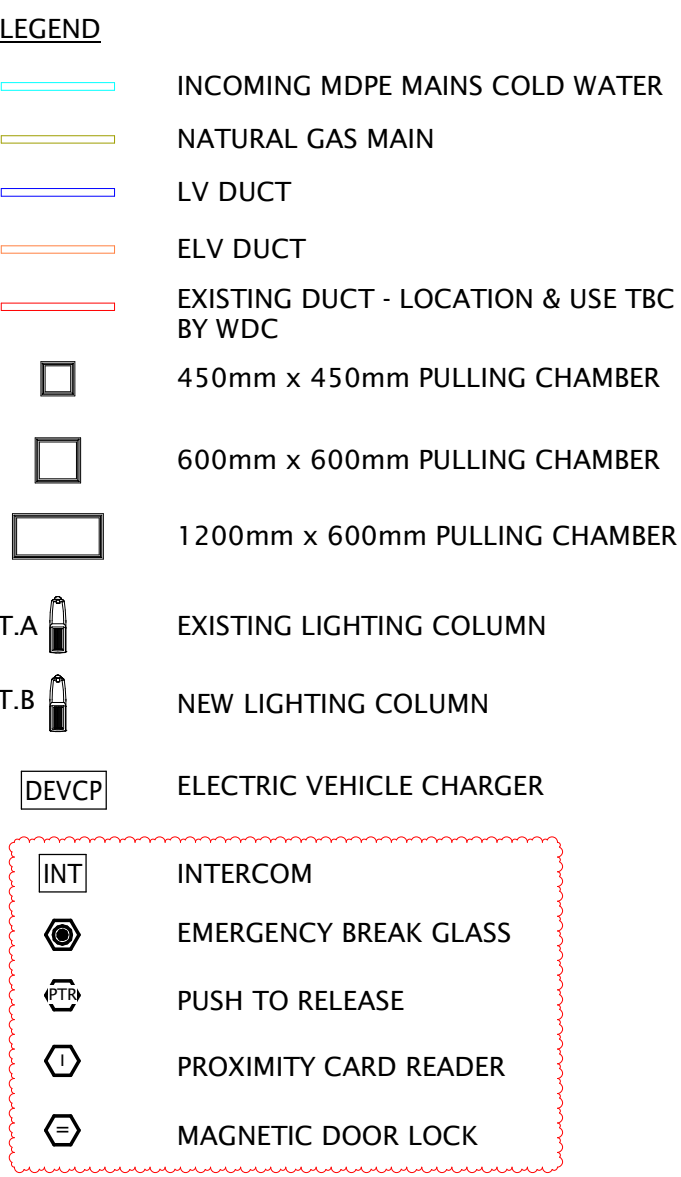
3. CLIENT TO ENGAGE WITH TELECOMS PROVIDER TO CONFIRM OPTIONS FOR THE INCOMING TELEPHONE SERVICE TO BE EITHER PROTECTED OR DIVERTED.
4. DIVERT POWER AND DATA LINES LOCATED IN THE SUBSTATION FROM THE PAVING AREA TO THE PERIMETER DUCT TO RECONNECT THE PARKING BARRIER AND PERIMETER DUCT RUN.

5. REMOVE AND STORE EVC CHARGING POINTS FOR USE BY CLIENT.
6. SUBSTATION EARTH NEST HAS BEEN INSTALLED WITHIN THE SUBSTATION PAVEMENT AREA. AS PER MARKUP RECEIVED FROM WDC. WDC TO LIAISE WITH SPECIALIST TO RETEST.

7. FIRE HYDRANT LOCATION INDICATED AS PER WDC MARKUP.
8. DUCTS TO CYCLE STORE TO BE REMOVED FROM THE SUBSTATION, AND CXTY TO BE STRIPPED OUT AND RETURNED FOR CLIENT USE.

9. ANY UNDETAINED INCOMING SERVICE ROUTES TO THE BUILDING TO BE MADE GOOD / SEALED.
10. CONFIRMATION OF BEAR CAGE INTERCOM REQUIREMENTS NEEDED.
11. FOR THE EXTERNAL SERVICES POSITIONS NEED TO BE VERIFIED ON SITE BEFORE FOUNDATION INSTALLATION.

12. WDC SHALL CONFIRM LOCATION OF EXISTING DUCTS BELOW GROUND SURFACE.
13. WDC SHALL CO-ORDINATE NEW BELOW GROUND SERVICES WITH BELOW GROUND ATTENUATION TANKS.
